Access Compliance Report

Intersection ID: 50709	Main Street: ARRIVAL_DR	Cross Street: BROTHERLY_LN	Location: NE
ADA ID: 0F81688E3579	Ramp Type: PerpDiag	Initial Pass/Fail: Fail	Overall Compliance: No
		Severity Score: 25

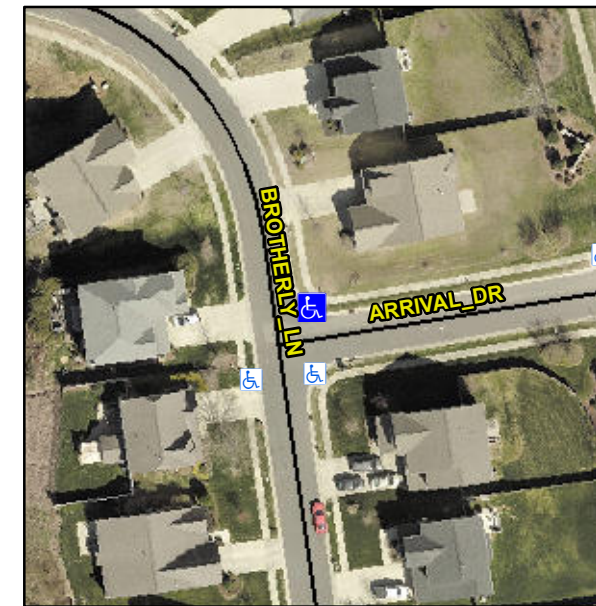
R304.5.3

Compliance	Description	Data	Compliance	Description	Data
N/A	Ramp Length (in)	95.0	Yes	Ramp Slope (%)	7.7
Yes	Ramp Width (in)	48.0	No	Ramp XSlope (%)	7.1
N/A	Flare Type LT	N/A	N/A	Flare Type RT	N/A
N/A	Flare Slope LT (%)	N/A	N/A	Flare Slope RT (%)	N/A
N/A	Flare Traversable LT?	N/A	N/A	Flare Traversable RT?	N/A
N/A	Landing Length (in)	N/A	N/A	DWS Provided?	N/A
N/A	Landing Width (in)	N/A	N/A	DWS Contrast?	N/A
N/A	Landing Slope (%)	N/A	N/A	DWS Length (in)	N/A
N/A	Landing X Slope (%)	N/A	N/A	DWS Full Width?	N/A
N/A	Landing Curb? (Y/N)	N/A	N/A	DWS Offset (in)	N/A
N/A	Shared Landing?	N/A			
N/A	Gutter Ponding?	N/A	N/A	Gutter Slope (%)	N/A
N/A	Gutter Lip Ht (in)	N/A	N/A	Gutter X Slope (%)	N/A
N/A	Painted X Walk1?	No	N/A	Painted X Walk2?	No
	X Walk 1 Direction	To W		X Walk 2 Direction	To S
N/A	X Walk 1 Width (in)	N/A	N/A	X Walk 2 Width (in)	N/A
	X Walk 1 Slope (%)	0.9		X Walk 2 Slope (%)	6.0
	X Walk 1 X Slope (%)	6.0		X Walk 2 X Slope (%)	5.7

Remove & Replace Curb Ramp With Two New Directional Ramps or Equivalent.
